REPORT DOCUMENTATION PAGE		READ INSTRUCTIONS BEFORE COMPLETING FORM	
1. REPORT NUMBER NJ00310	2. GOVT ACCESSION NO.	3. RECIPIENT'S CATALOG NUMBER	
4. TITLE (and Subtitle) Phase I Inspection Report National Dam Safety Program Swannanoa Lake Dam #2 Morris County, NJ		5. TYPE OF REPORT & PERIOD COVERED 9 FINAL rept.

PHASE I INSPECTION REPORT
NATIONAL DAM SAFETY PROGRAM

NAME OF DAM:	SWANNANOA LAKE DAM #2
ID NUMBER:	FED ID No. NJ00310
STATE LOCATED:	NEW JERSEY
COUNTY LOCATED:	MORRIS
STREAM:	TRIBUTARY OF ROCKAWAY RIVER
RIVER BASIN:	PASSAIC
DATE OF INSPECTION:	30 November and 1,11,12 & 16 December 1978

OVERVIEW
SWANNANOA LAKE DAM #2
1 DECEMBER 1978

Wooden trash rack at spillway inlet.

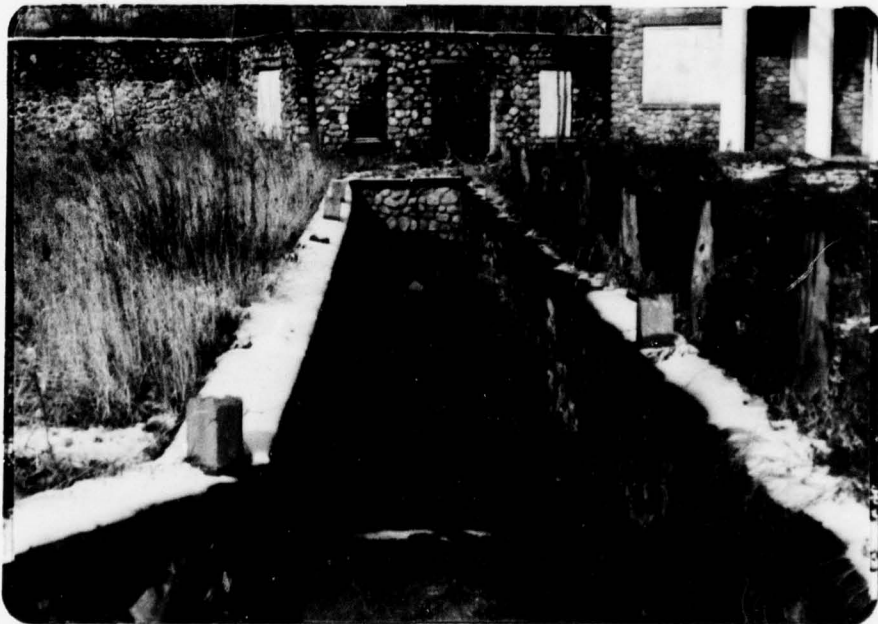
(1) The trash rack should be made functional in order to prevent the drop inlet from becoming clogged with debris.
